SERVICE PROGRAM

SP 3-144-004

**SUBJECT: REPLACE INSTRUMENT
CLUSTER LIGHT BAR**

**VEHICLES AFFECTED: AUTOCAR ACX MODEL
VEHICLES BUILT BETWEEN 30
NOVEMBER 2007 AND
22 SEPTEMBER 2008, VIN
RANGE 206686 TO 208559**

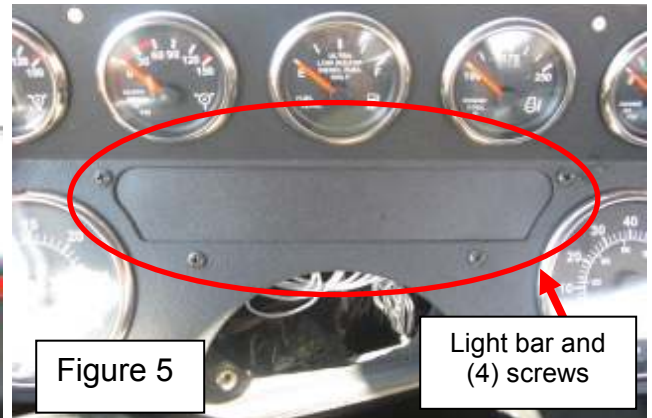
5. Remove the A1441001-001 or A1441004-001 light bar from the instrument cluster by removing the (4) screws with a ratchet or Phillips screwdriver. See Figure 5 showing the light bar screw locations.

6. Install the A1441009-001 light bar to the instrument cluster with (4) screws and a Phillips screw driver.
7. Reinstall the (2) white harness connectors to the back side of the A1441009-001 light bar.
8. Reinstall the instrument cluster to the dash with (8) screws and a Phillips screw driver.
9. If the steering column bolts were removed, position the steering column back into the correct position and install the column bracket with (4) bolts.
10. Tighten the (4) steering column bracket bolts with a ratchet and 9/16" socket and torque the bolts to 30+/-3 Ft-lbs. with a torque wrench.
11. For an ACX dual-drive truck, move to the opposite side of the cab, and repeat Step 3 through Step 8 for the opposite side light bar.
